Kentucky Power Company
KPSC Case No. 2022-00236
Commission Staff's First Set of Data Requests
Dated September 22, 2022

DATA REQUEST

KPSC 1_1 Refer to the Application, page 1. Explain whether there is an active case in West Virginia before the West Virginia Public Service Commission regarding that portion of the Stone-Sprigg 46 kV line located in West Virginia. If so, provide a link to the case and a corresponding timeline for the case. If not, explain whether a case will or will not be opened, including a timeline for the case. If a case will not be opened, explain why not.

DETAILED MAPBOOK SHEET 9 OF 12

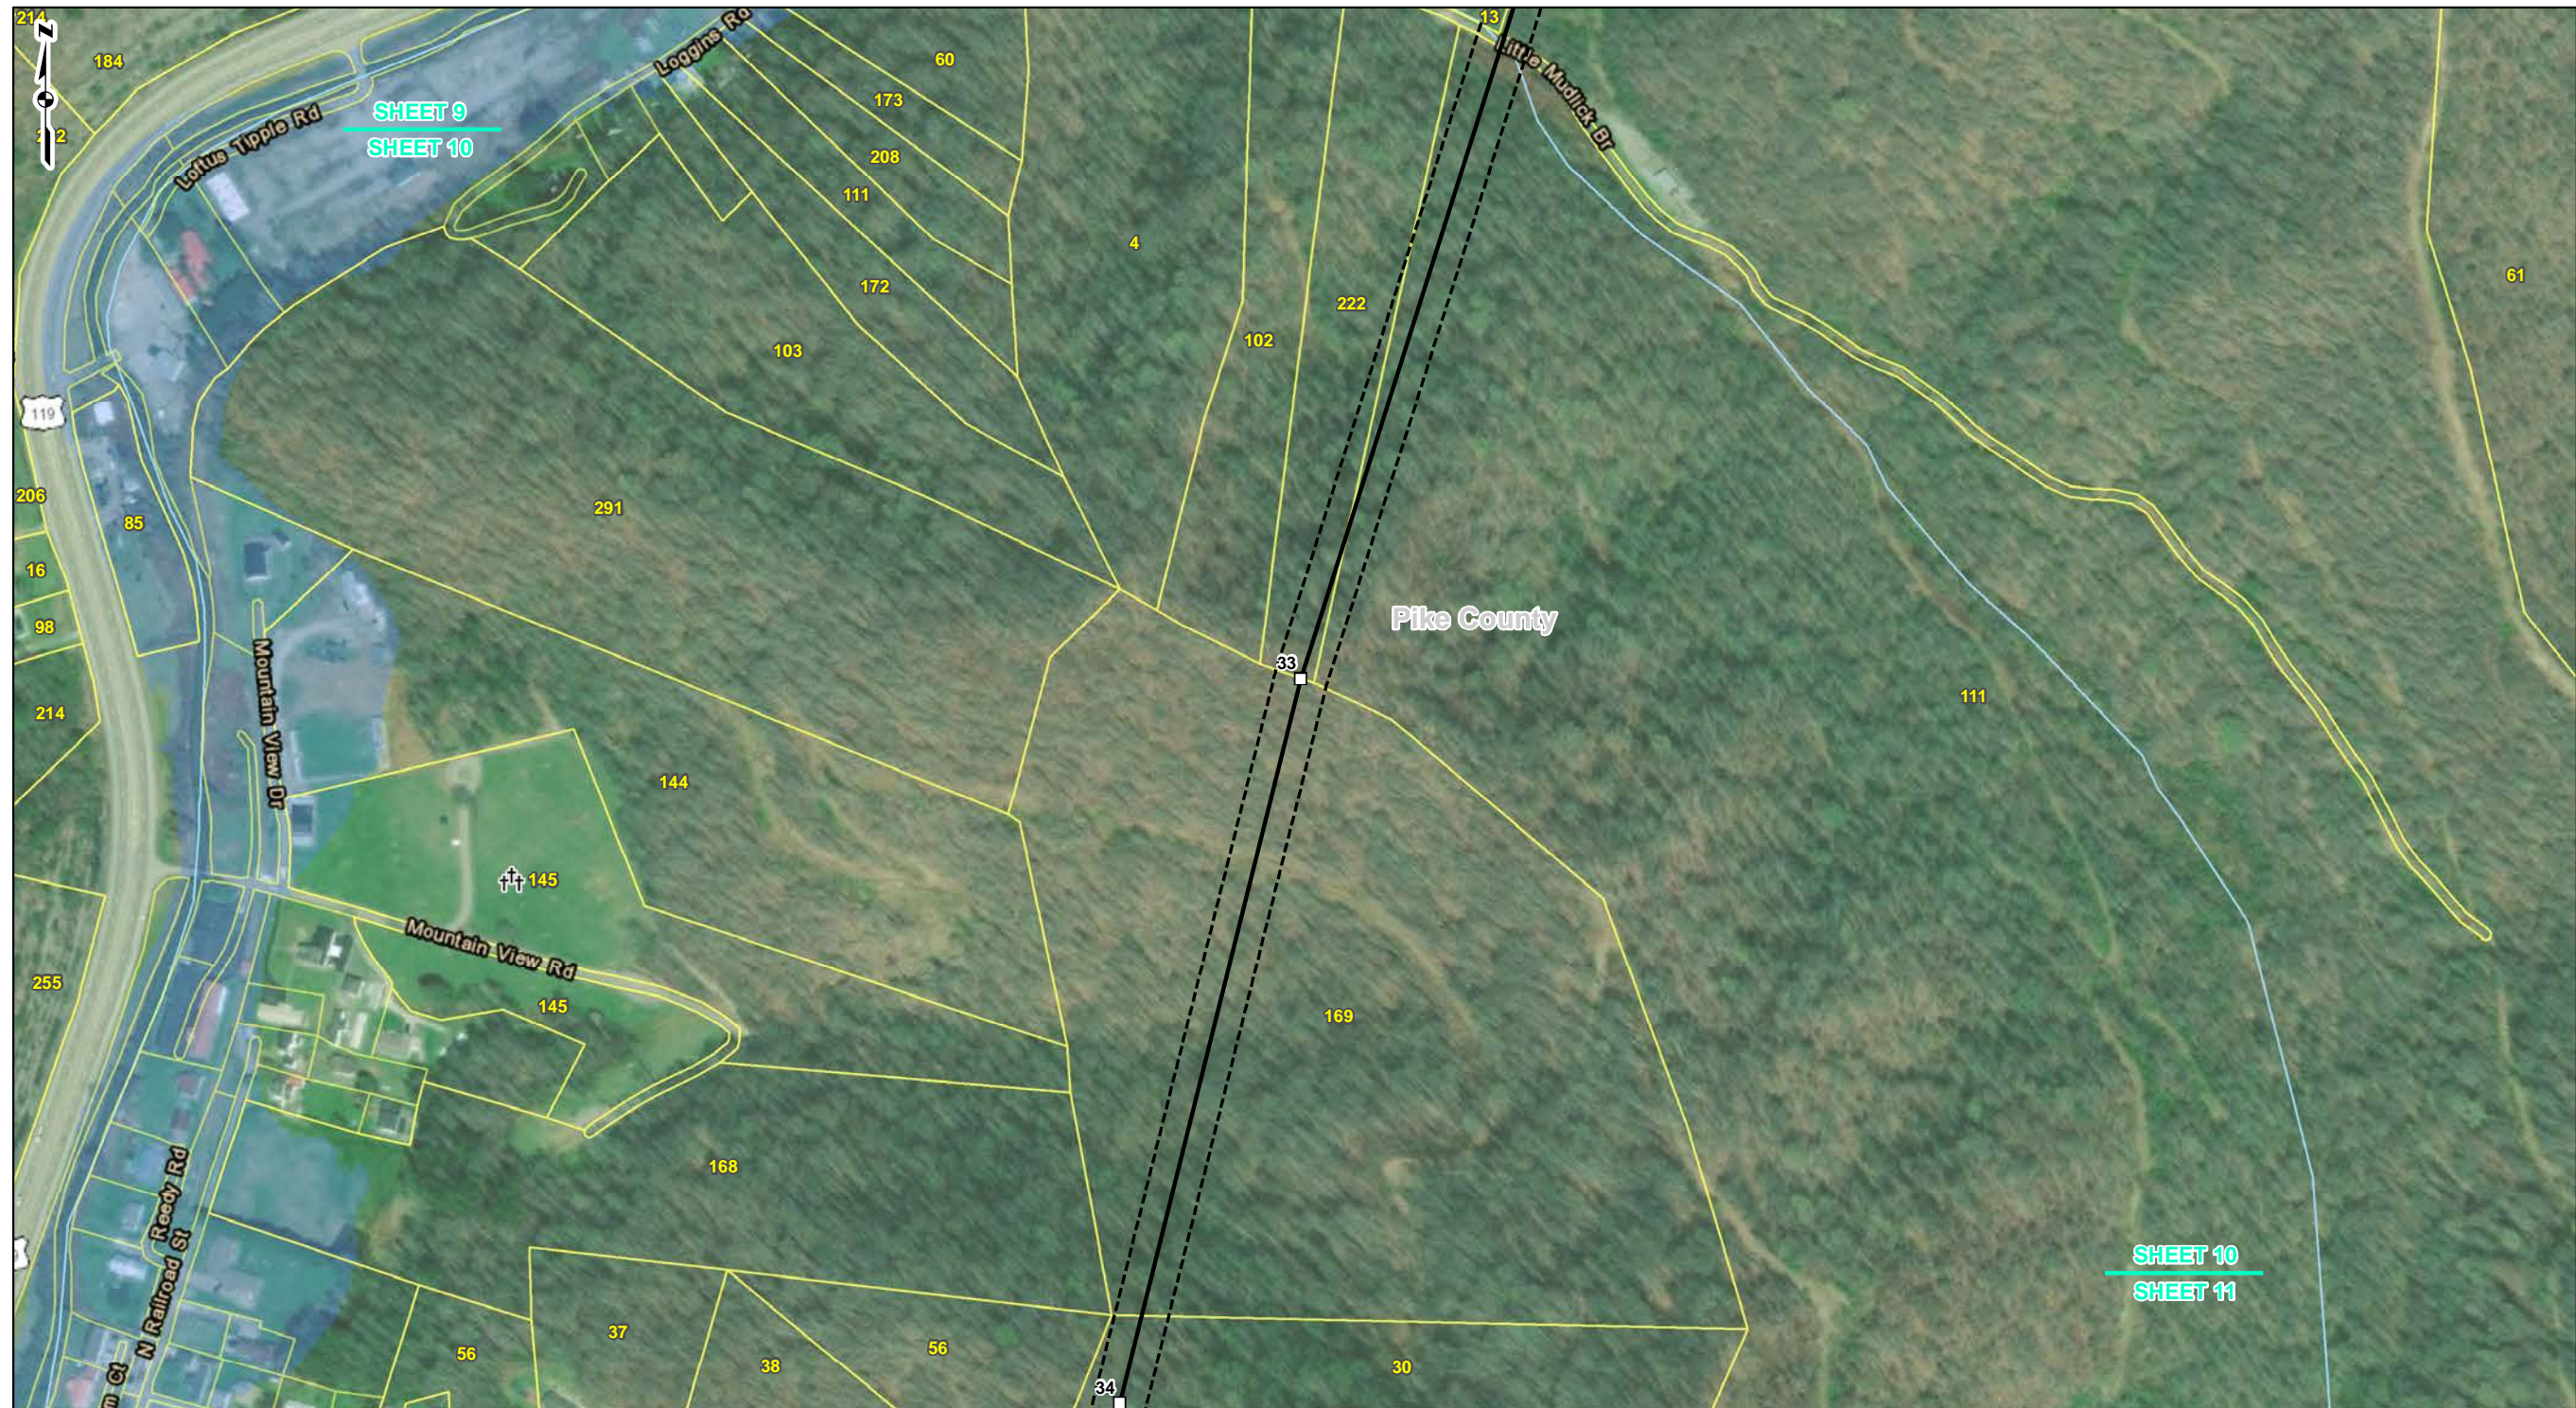
KPSC 1_4 Refer to the Application, Exhibit 10, Attachment C, Map 3 Alternative Routes, page 47 of 92; and Attachment H, Sheet 9 of 12, page 89. Map 3 shows a cemetery very close to the line entering the proposed Orinoco substation from the north. Confirm that the map on Sheet 9 of 12 and Map 3 depict the same cemetery location.

Both of these maps depict the same cemetery, which was identified from GIS databases. The apparent proximity to the Proposed Route on Map 3 is a result of the difference in symbology size and scale between the maps.

KPSC 1_33 Attachment

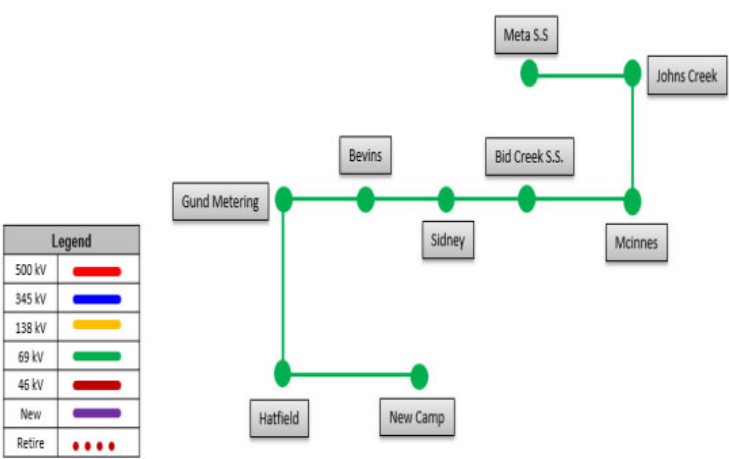
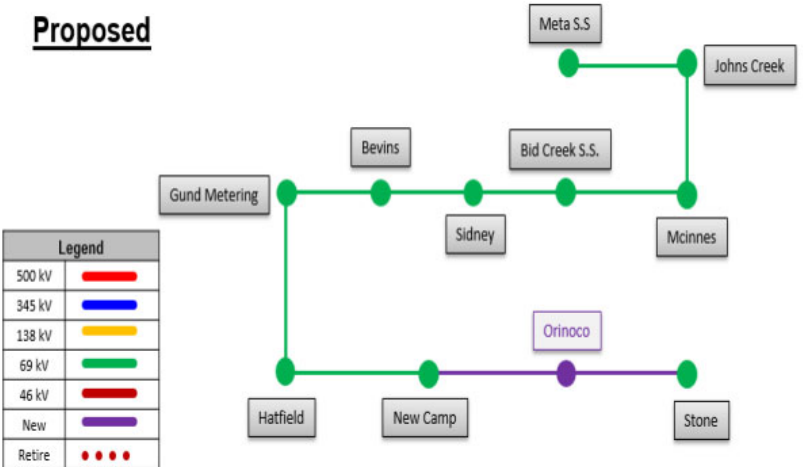
KPSC 1_33 Provide documentation regarding the specific voltage violations, including locations, frequencies and any charts documenting the PJM violations.

Please see KPCO_R_KPSC_1_33_Attachment1. The attachment includes information presented at PJM and references the baseline work to be completed. The voltage violation two flow gates, AEP-VD160, and AEP-VD1161 at New Camp Substation and the baseline alternatives are displayed in the links to the PJM subregional slides.
